Preliminary Information

PIP5811 Crankshaft Balancer Contacting Timing Cover on Replacement Engine

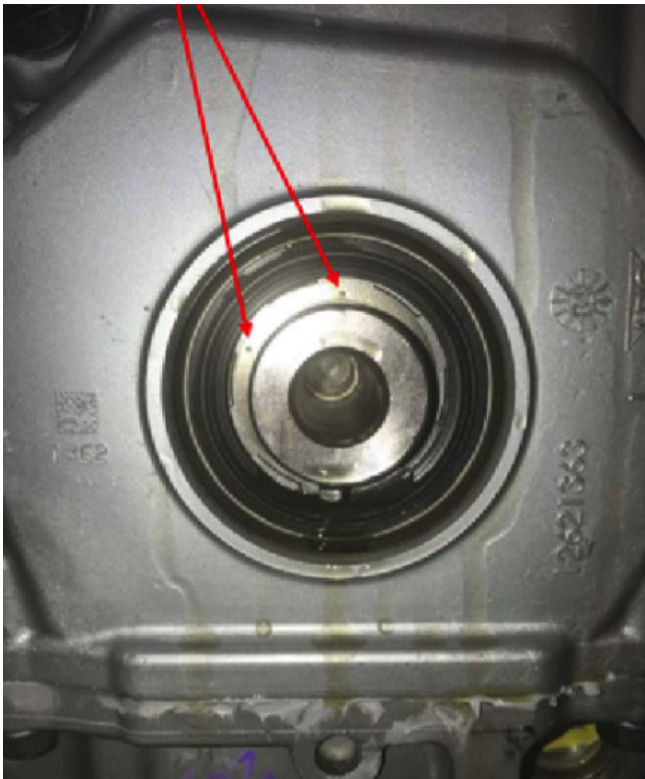
To identify if the engine was assembled with the incorrect crankshaft timing gear inspect for 5 dimples on the crankshaft timing gear (the incorrect gear will NOT have these dimples present), the dimples should be visible with the cover installed and balancer removed (see below):

Further confirmation can be made with the timing cover of and measuring from the end of the crankshaft to the end of the gear (see below), this measurement should be approximately 1 1/16" (27.0mm).

If it has been confirmed that the lower crankshaft timing gear is incorrect, crankshaft timing gear P/N 12631214 along with a new oil pump will need to be installed.
